# Kirtland Air Force Base Fuel Spill RCRA Facility Investigation Reports

RFI Review Comments

**New Mexico Environment Department**

August 14, 2014

(KAFB Stage 2 Abatement Plan Modification, August 1, 2007, p. 3-9)

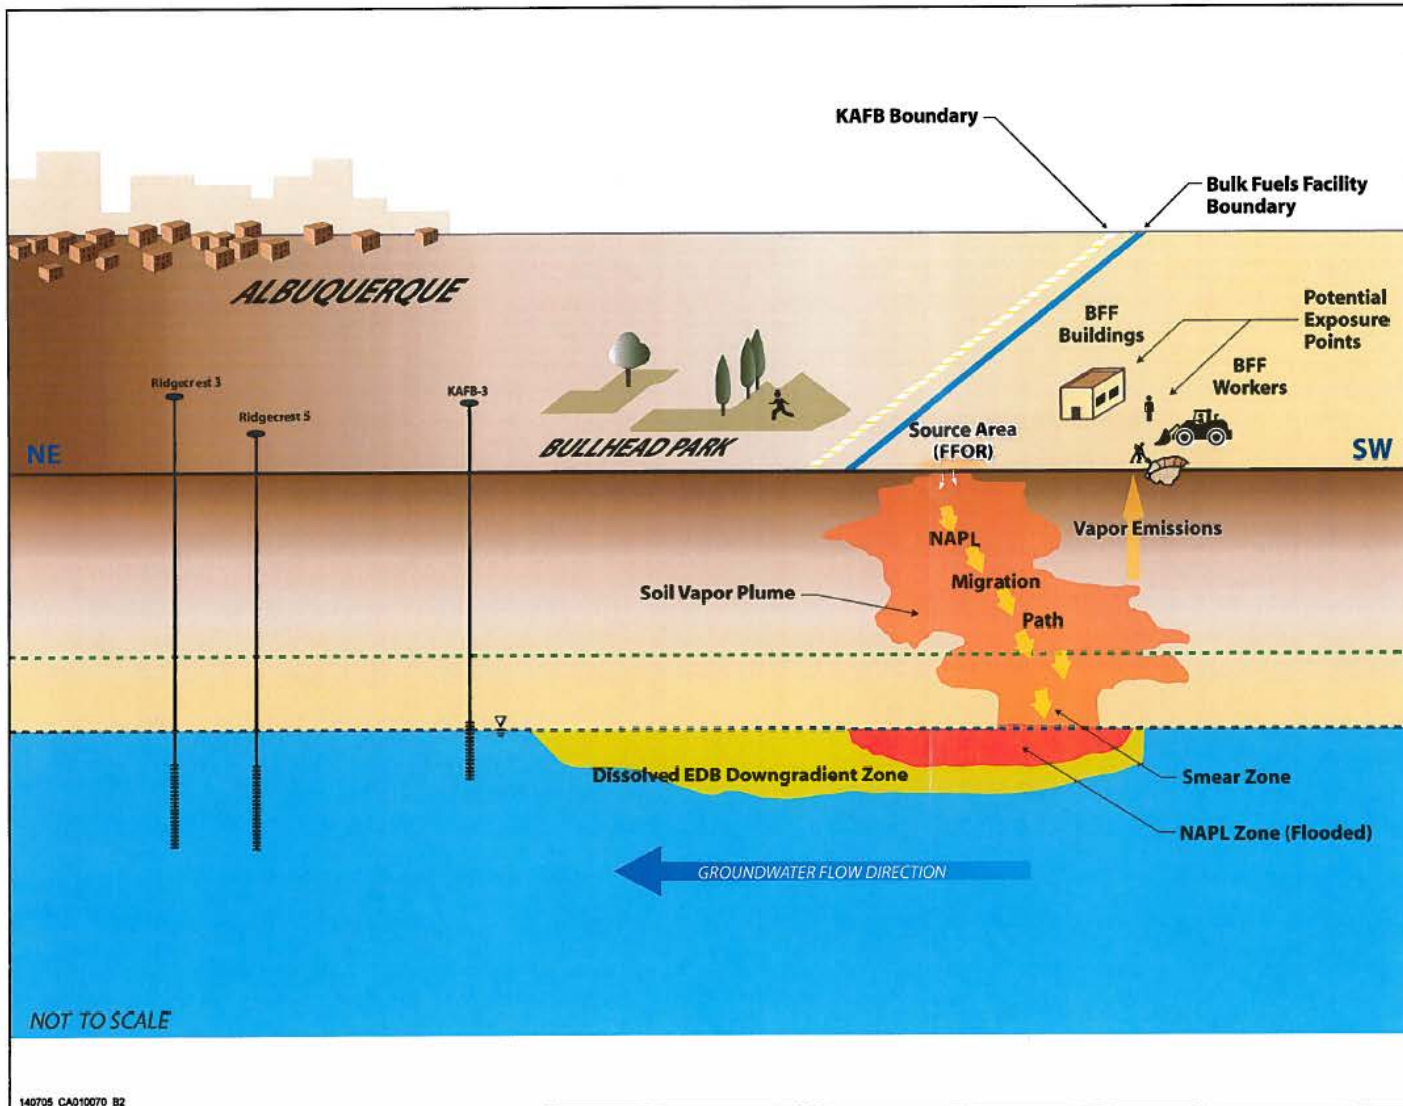
**➔ The RFI does not discuss this previous corrective action, and its outcome, in Section 2, Background Information. This historical action may become important if significant floating LNAPL occurs at the site again.**

FIGURE 7-1

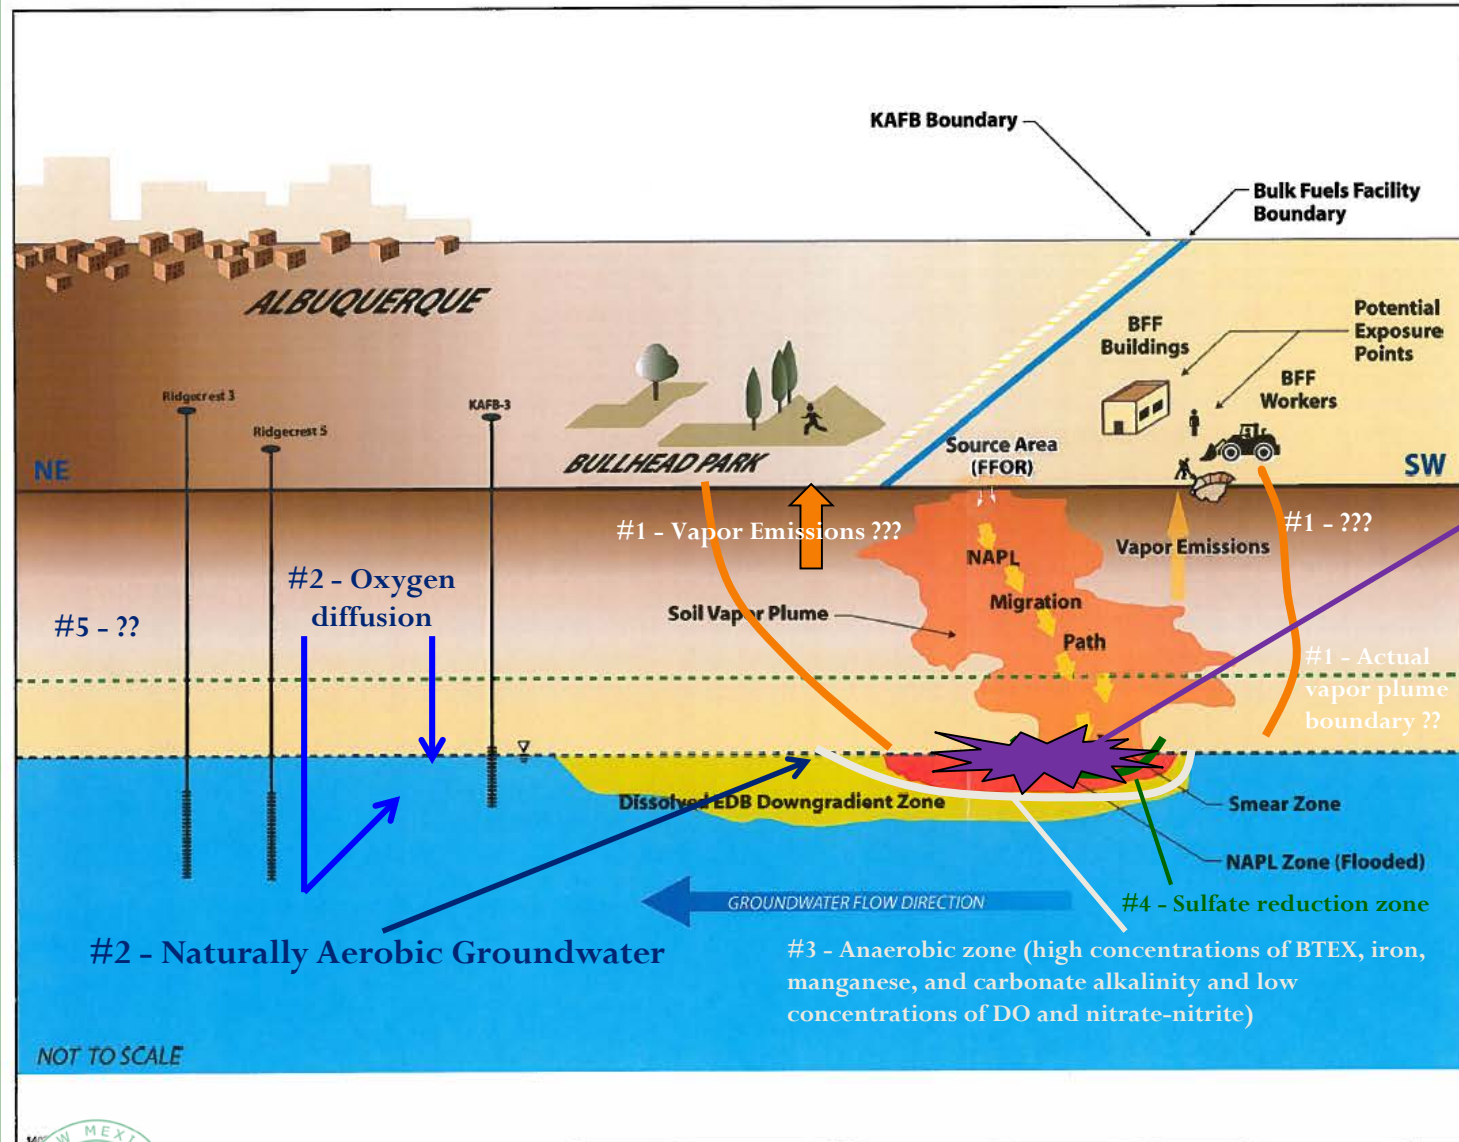
- #1 - CSM suggests a vapor exposure pathway to KAFB workers
  - Vapor exposure is not discussed in the RFI
  - What is the basis exposure pathway?
  - What concentrations might workers be exposed to?
  - What precludes vapor exposure pathways in other directions and off the base?
- #2 - Analysis of groundwater background quality, critically important with regard to hydrocarbon biodegradation and other impacts to the aquifer
  - Incomplete in the RFI report.
- #3 - The anaerobic plume core and other redox zones are not illustrated and discussed relative to each other and to dissolved contaminant phases.

- #4 - The sulfate reduction and methanogenesis redox zones were not identified either in the RFI or in the conceptual model.
- #5 - The CSM does not contain readily available geologic information that has been discussed at length in previous meetings
- Model fails to provide a comprehensive understanding of the physical, chemical, and biological processes that influence contaminant fate and transport. Understanding all processes that occur at the site is critical for corrective measure evaluation and selection.

# Plume Definition

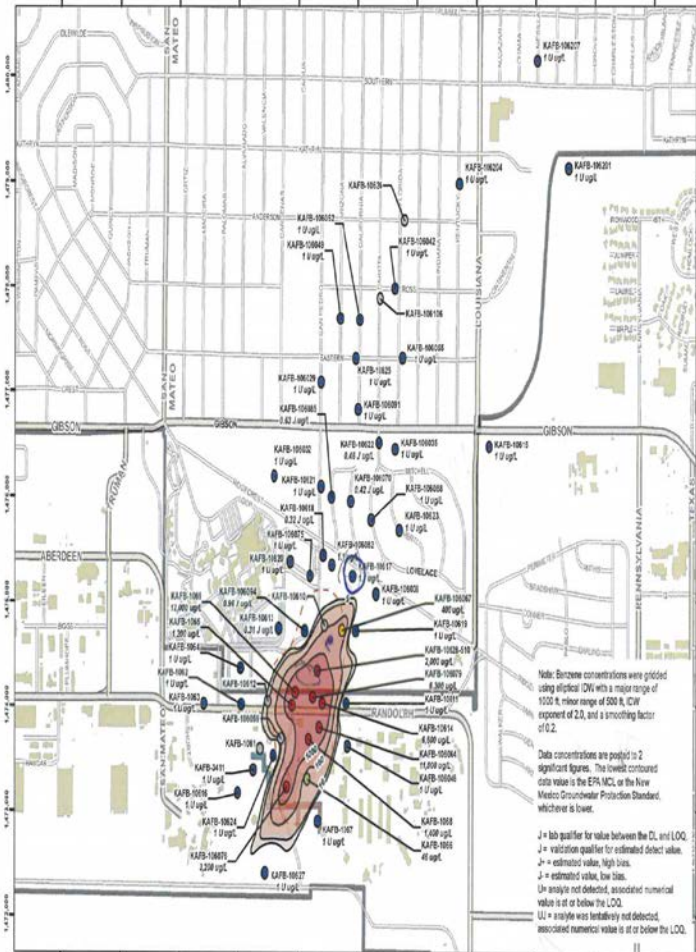
- Characterization of the vertical extent of the dissolved-phase contamination in the groundwater and the effect of vertical gradients.
- Characterization of the leading edge (northern) and eastern and western margins of the NAPL, benzene, and EDB plumes” (RFI, page 2-7)

# Vertical Extent of LNAPL Not Defined

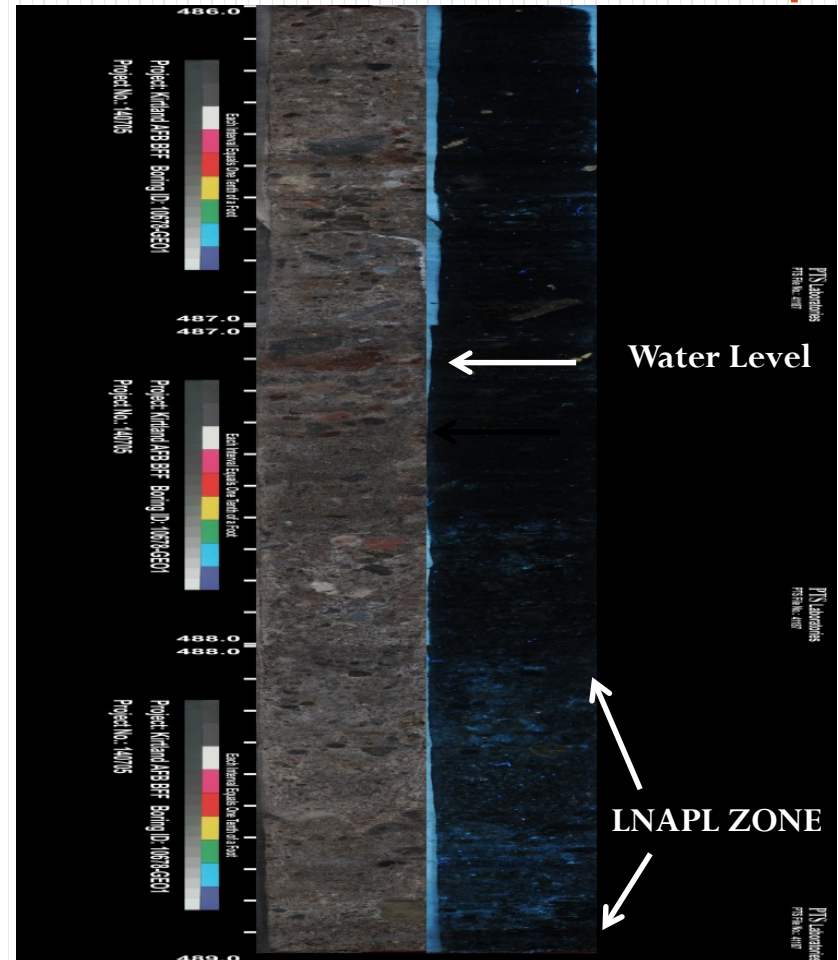
## Drowned LNAPL in core sample

# Erroneous/Misleading Graphics

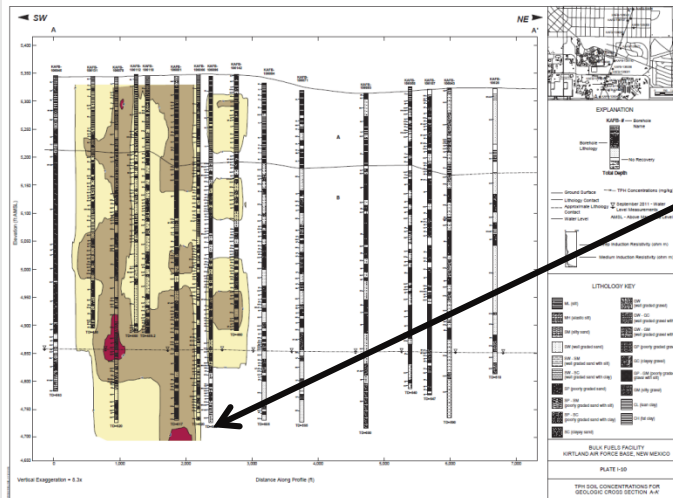
Graphics indicate sediment contamination 150 feet deep in the aquifer.

*This is deeper than any boring/monitoring well at the site and is not discussed in the text. Graphics are misleading and most likely wrong.*

TPH in soil 150' below water table

Well ID KAFB-016

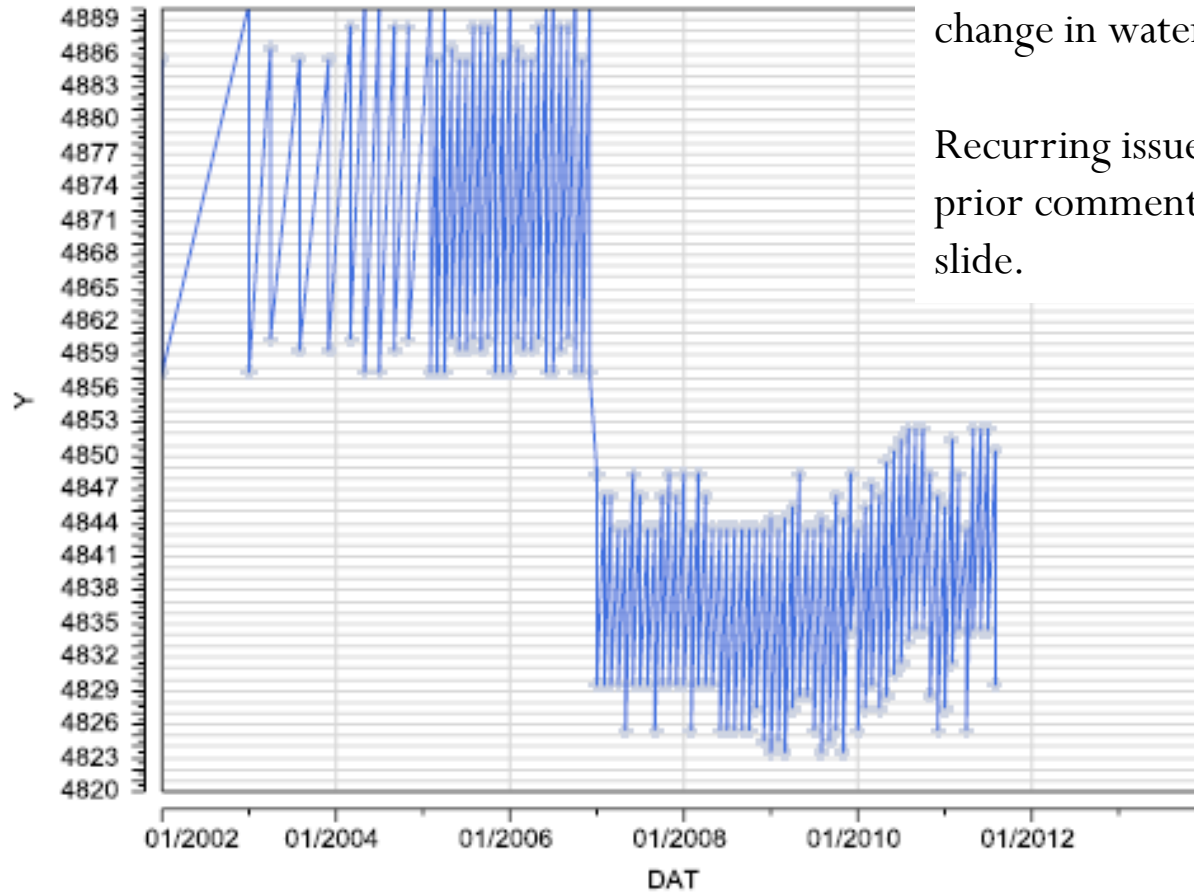
No description or correction of major change in water level.

Recurring issue - NMED has made prior comment on this and previous slide.

# Conflicting Lithology Interpretation

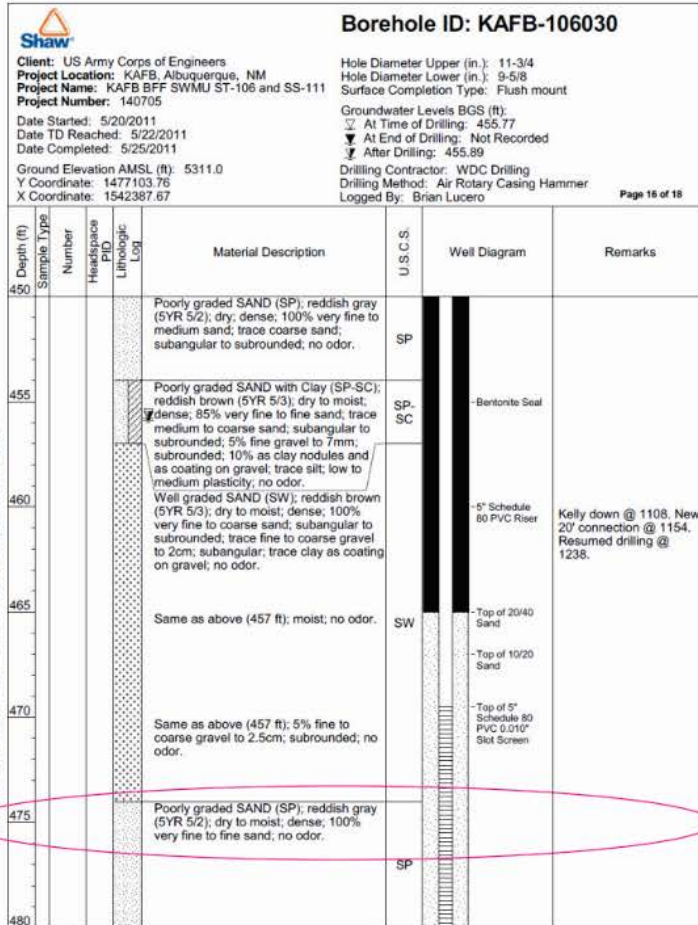
**KAFB 106-030 at 475 feet: Borehole log describes it as 100% very fine to fine sand; Particle size analysis describes it as gravel.**

# Significance of Anaerobic (Low Dissolved Oxygen) Zone Footprint

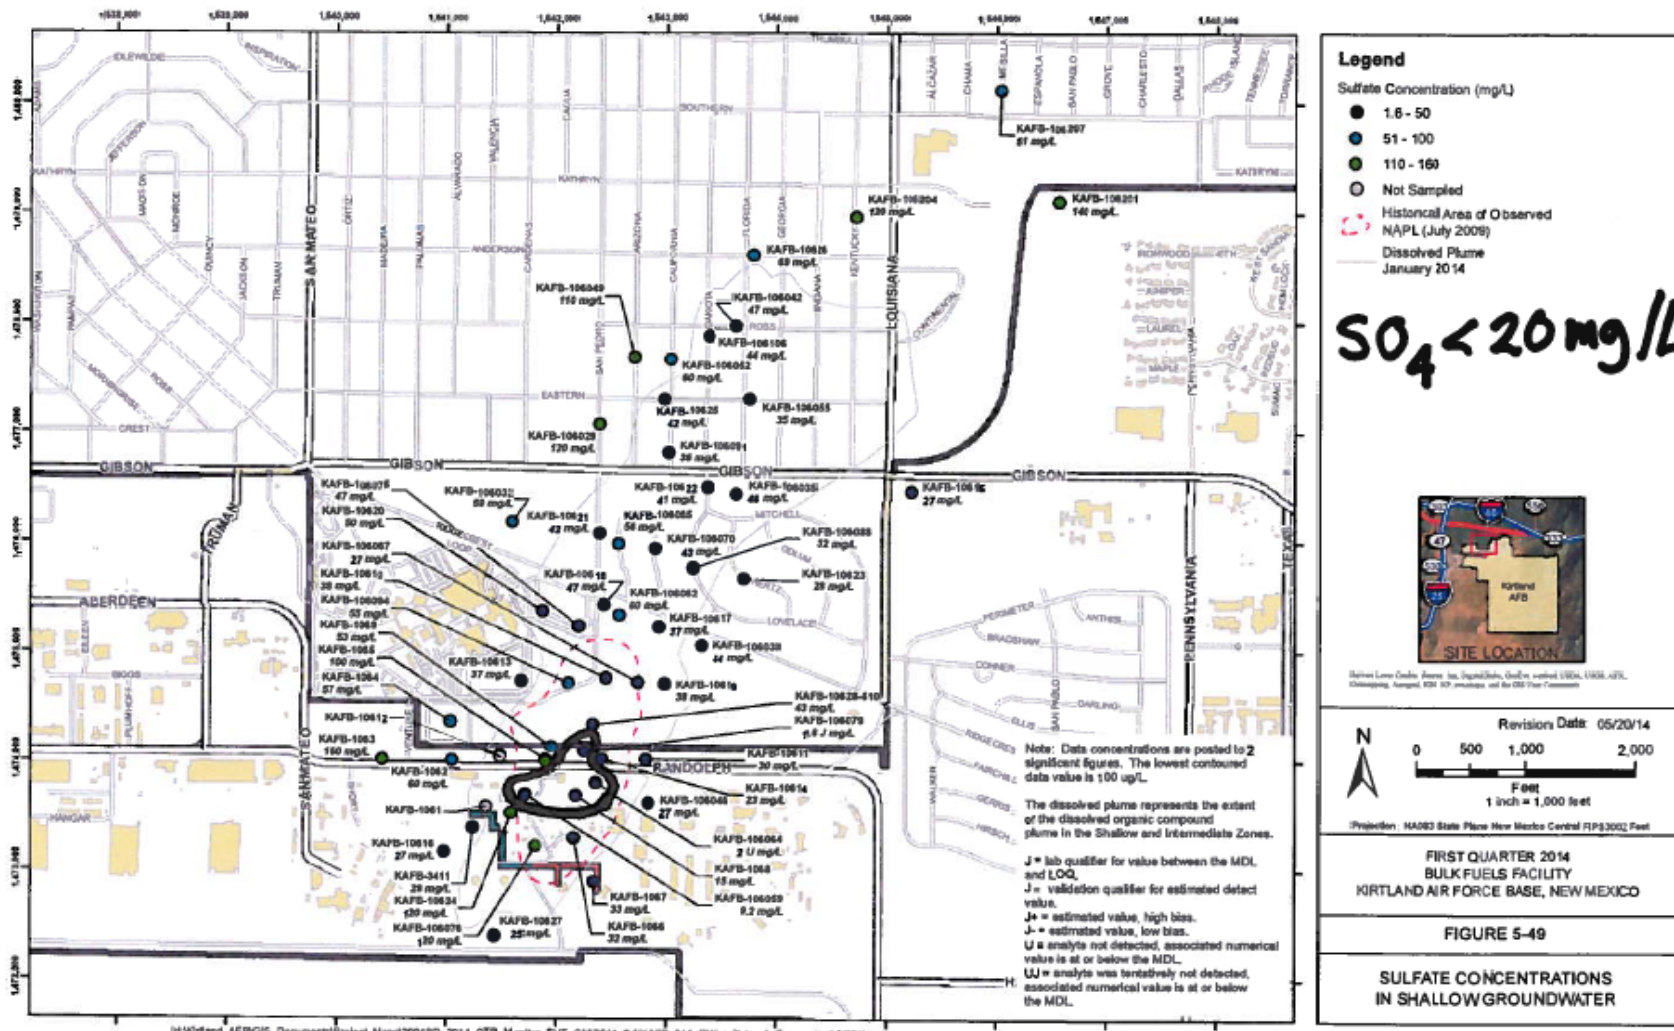
- DO is an important parameter and was not presented in the RFI
- Anaerobic conditions with high concentrations of electron donors (BTEX) are most favorable for EDB biodegradation.
- If the anaerobic zone has, in fact, been shrinking, this has profound implications for corrective measure evaluation and selection.
